UNITED STATES PATENT AND TRADEMARK OFFICE

APPLICATION NO.	FILING DATE	FIRST NAMED INVENTOR	ATTORNEY DOCKET NO.	CONFIRMATION NO.
09/748,277	12/27/2000	Jac-Lag Ma	8733.363.00	4729

**Office Action Summary**

## DETAILED ACTION

Fig. 1

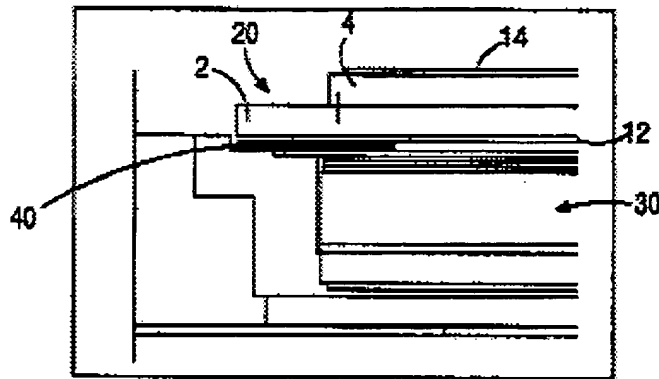
As to claims 6 and 9-12, APA discloses in Figures 1-4 (Specification pages 2-4), a dot matrix (Specification, Page 2, lines 18-22) liquid crystal display (LCD) device, comprising:

an upper polarizer, 14; on an upper substrate, 4;

a lower substrate, 4, on a lower polarizer, 12;

a liquid crystal layer (not shown) disposed between the upper substrate and the lower substrate; and

a backlight device, 30, disposed opposite and adjacent to the lower polarizer for emitting light toward the lower polarizer (Figure 1) (please note that adjacent does not preclude structures between those items considered to be adjacent, e.g., two houses may be adjacent despite the existence of an intervening garage);

wherein at least a black pad, 40, that acts as a light shield (Applicant's light shielding layer) formed in a rectangular shape having a substantially centrally located rectangular opening resulting in light shielding layer substantially shielding exclusively the peripheral portion (evident from Specification, Page 3, lines 11-14) of the lower polarizer to permit light to pass through the rectangular opening; wherein the light shielding layer only blocks a portion of the light traveling to four peripheral sides of the lower polarizer for minimizing constructive interference at a peripheral portion of the LCD device; and wherein the light shielding film absorbs light (inherent property of the color black).

APA does not explicitly disclose a lower polarizer that includes said light shielding film.
